Stage 1 Safety Audit & Designer's Response

**The Lillies Caravan Park
Yapton Road, Barnham, West Sussex**

Road Safety Audit
Stage 1 - Preliminary Design

Copy of Drawing Numbered 21882/10

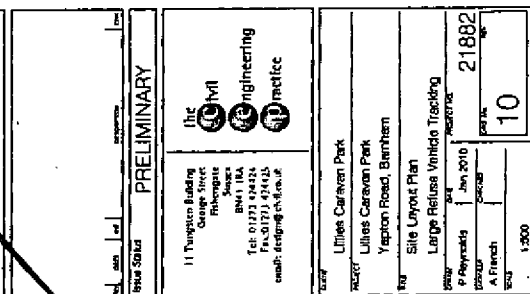
Although junction visibility splays of 2.4m x 70m are shown on the design drawings, the boundary lines of those splays appear to pass through the existing tall hedges that are close to the edge of the main carriageway, whereby obstruction of those splays may result. Furthermore, if the existing low height hedge across the frontage of dwelling number "47" is subsequently allowed to grow taller, it also may obstruct the proposed visibility splay.

As part of the site access changes, the existing hedges should be removed or suitably cut back to a line behind the proposed visibility splay and that section across the frontage of dwelling "47" should also be removed and if replacement is considered it should be replanted behind the line of the visibility splay.

Although proposed works involve closure of the existing access to the Caravan Site, since it jointly provides vehicular access to that site and to number "47", the east side of the existing access will need to be maintained to that dwelling.

As part of the site access changes, the existing wide access will need to be reduced and appropriate vehicle crossover with suitable adjacent upstand kerbing should be provided, which clearly distinguishes it from the new bellmouth to the nearby development site.

Although the proposed access bellmouth is shown with footway works involving tactile paved dropped crossings at each side of the bellmouth, since no footway is currently provided along the south side of Yapton Road, pedestrians entering and leaving the development site will need to reach the existing footway along the north side of the main road.

At each side of the new bellmouth the indicated footways should be extended sufficiently east and westwards to enable tactile paved dropped crossings to be provided across Yapton Road.

<u>Safety Audit Comment</u>	<u>Recommendation</u>	<u>Designer's Response</u>
A1 GENERAL		
A1.1 COMMENT		
No Relaxations or Departures from Standards were reported by the Designer for this scheme.		Noted.
A2 LOCAL ALIGNMENT		
No road safety related issues are identified in this category at this stage.		Noted.
A3 JUNCTIONS		
A3.1 PROBLEM		
Location: Proposed new access to the development site. Summary: Risk of existing hedges obstructing junction visibility splays. Although junction visibility splays of 2.4m x 70m are shown on the design drawings, the boundary lines of those splays appear to pass through the existing tall hedges that are close to the edge of the main carriageway, whereby obstruction of those splays may result. Furthermore, if the existing low height hedge across the frontage of dwelling number "47" is subsequently allowed to grow taller, it also may obstruct the proposed visibility splay.	As part of the site access changes, the existing hedges should be removed or suitably cut back to a line behind the proposed visibility splay and that section across the frontage of dwelling "47" should also be removed and if replacement is considered it should be replanted behind the line of the visibility splay.	Agreed. The visibility splays have been reduced to 2.4m x 43m in accordance with Manual for Streets for a 30mph road. The hedge to number 47 is to be removed and replanted behind the visibility splay as shown on drawings 21882/10A & 11A.

The existing access will be closed and reinstated with footway and full height kerbs. A vehicular crossover will be provided to number 47 Yapton Road as shown on drawings 21882/10A & 11A.

Agreed. Footways added together with tactile paving crossings over Yapton Road as shown on drawings 21882/10A & 11A.
